CITY OF ALBUQUERQUE

**RE: 527 Mesilla Street NE
Grading and Drainage Plan
Engineer's Stamp Date: 05/14/24
Hydrology File: L19D079**

GRADING & DRAINAGE PLAN

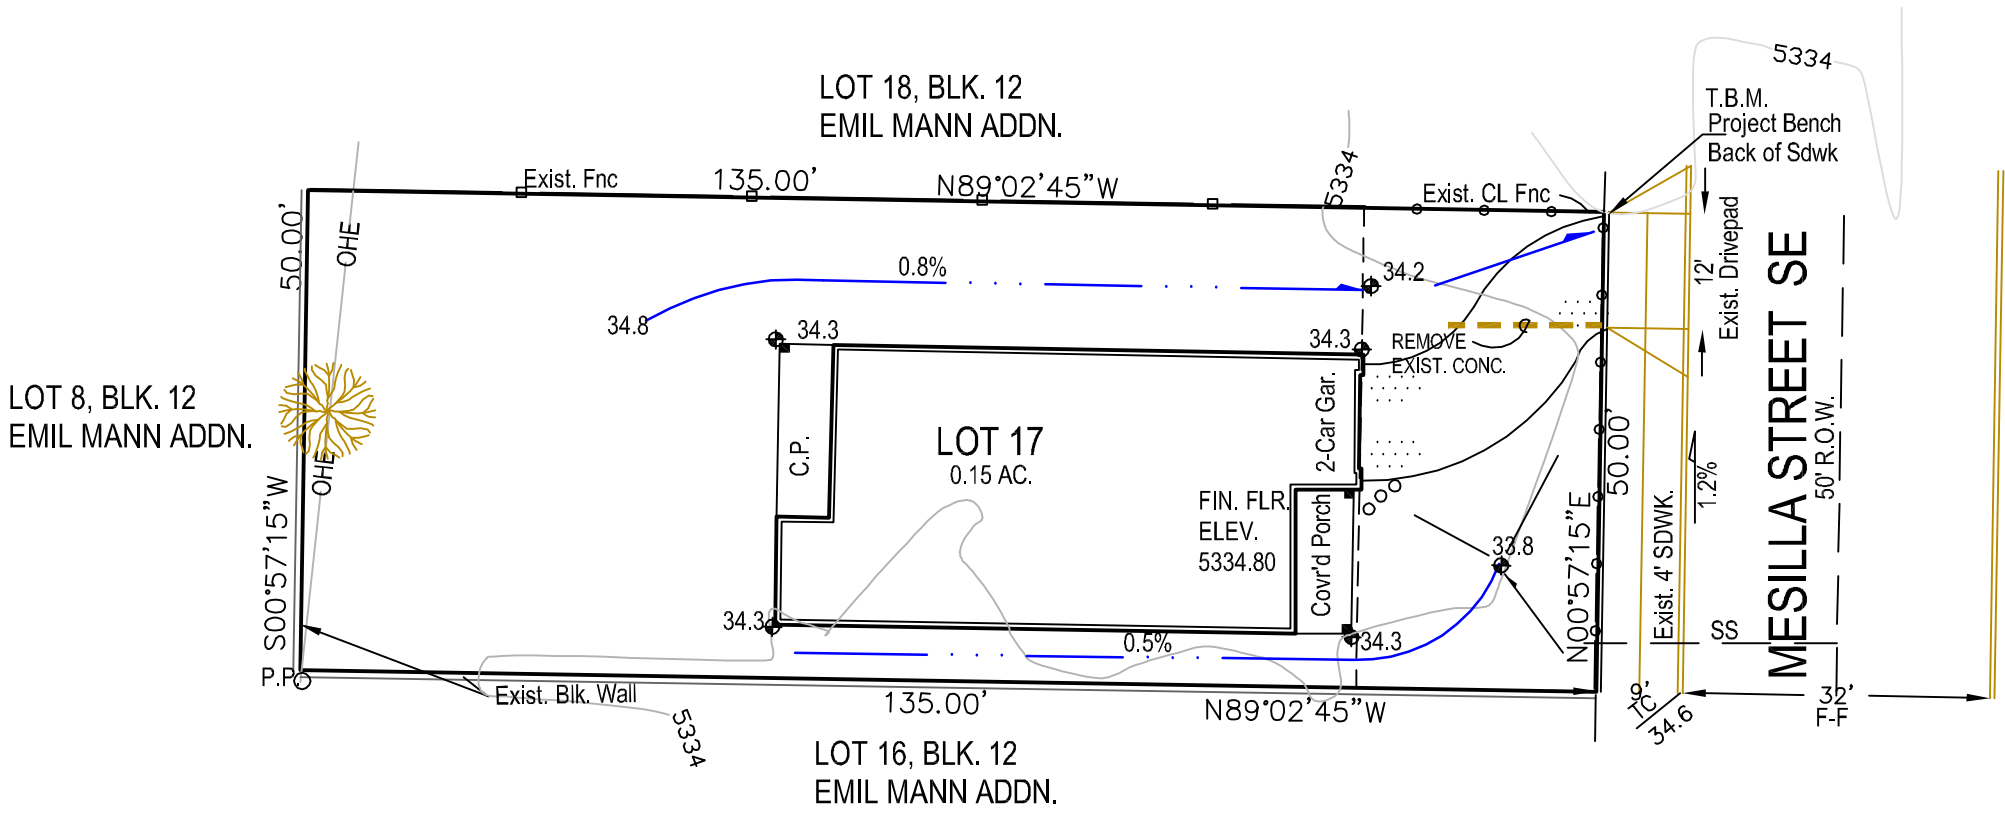
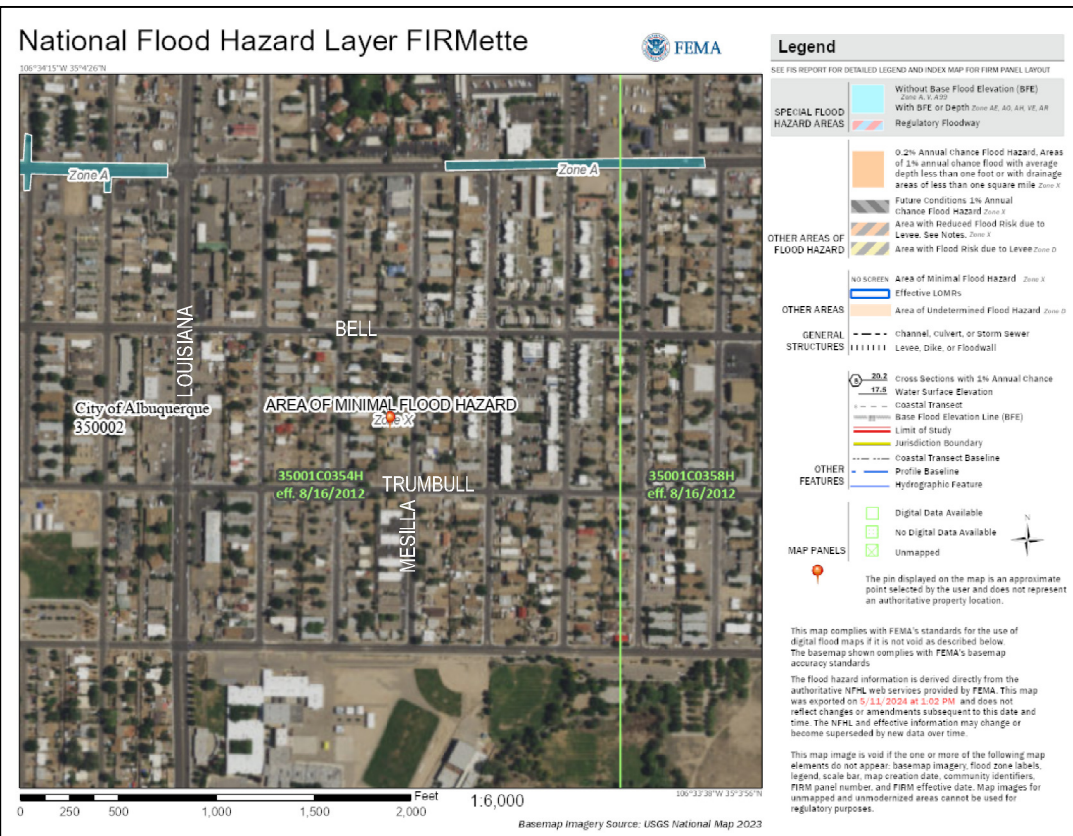
Based upon the information provided in your submittal received 05/16/2024, the Grading and Drainage Plan is approved for Building Permit and Grading Permit. **Since this site is relatively flat and grades to the road, a pad certification is not needed for this project.** Please attach a copy of this approved plan in the construction sets for Building Permit processing along with a copy of this letter.

1. Engineer's Certification, per the DPM Part 6-14 (F): Engineer's Certification Checklist For Non-Subdivision is required.
